STAFF REPORT

Case #: 21-40 Site Plan Review
105 William Street
Map: 52 Lot: 345

Overview: Request by applicant for Site
Plan Review for the
conversion of upper floor
office space to 21 residential
units and associated site
improvements.

Site Photos

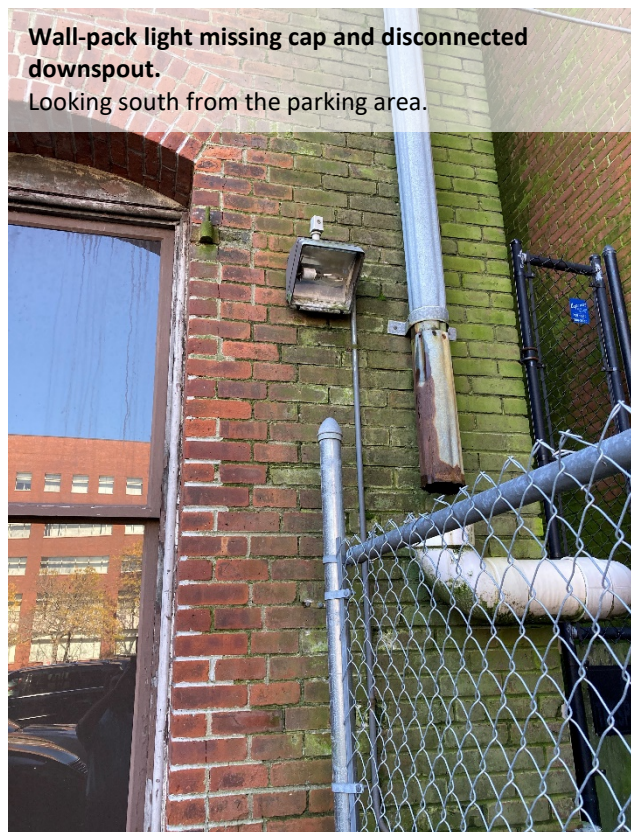
Trash bins and air conditioner units at the rear of the site.
Looking south from the parking area.

Wall-pack light missing cap and disconnected downspout.
Looking south from the parking area.

Downspouts connecting to underground piping.
Looking south from the parking area.

1. The parking lot lighting shall be repaired and or replaced with new down-shielded light fixtures. The applicant shall submit revised plans indicating site lighting locations and specifications to the Department of City Planning to review prior to the issuance of a building permit.
2. The area adjacent to the rear egress door shall be stripped no parking area. Revised plans are to be submitted to the to the Department of City Planning to review prior to the issuance of a building permit.
